Statement of Response to An Bord Pleanála's Opinion

Prepared in support of a proposed Build-to-Rent Strategic Housing Development on lands associated with St. Laurence College, Wyattville Park, Loughlinstown, Co. Dublin

On behalf of: Green Urban Living N11 Limited

June 2021

Figure 2.5: Transport Infrastructure Map.

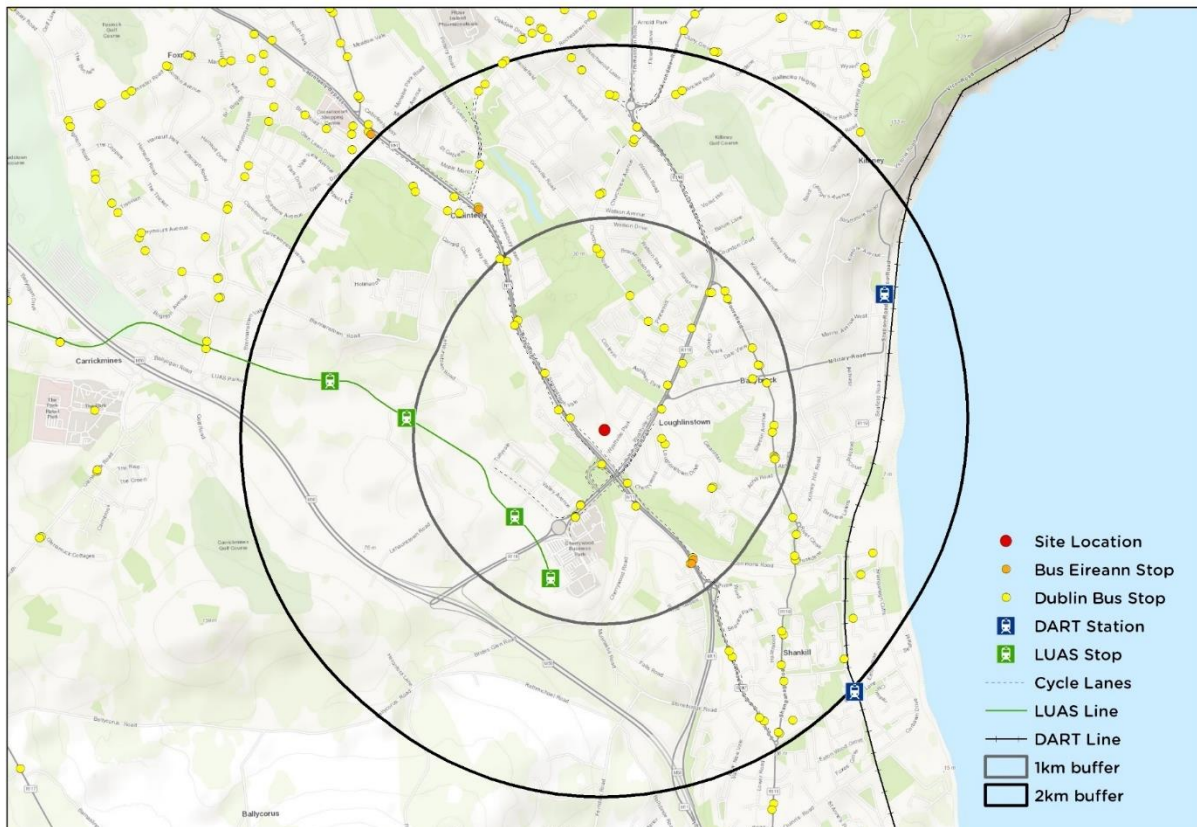
“Further consideration of the documents as they relate to pedestrian permeability and the accessibility of the site to locally available public transport and the emerging Cherrywood Town Centre with respect to sustainable transportation. This further consideration should detail and map all relevant local facilities and services such as parks, schools, commercial services and public transport networks amongst other things. Pedestrian and cyclist routes should also be detailed on and off the site, with particular attention for accessibility to and from the N11 having regard to convenience and safety. Pedestrian and cyclist permeability through the site should also be shown in the context of the masterplan exercise for the

entire school lands, where student and teacher accessibility is of importance. The internal layout of the entire site should comply with the advice provided by the Design Manual for Urban Roads and Streets and put the pedestrian and cyclist first in the design process. Further consideration of these issues may require an amendment to the documents and/or design proposals submitted”.

Response: The subject site benefits from excellent accessibility to both public transport due to its immediate proximity to the N11 and its associated Quality Bus Corridor, as well as close proximity to Cherrywood Luas Stop and proximity to Killiney Dart Station (Figure 2.5), and services and facilities due to its location in a well-established suburb.
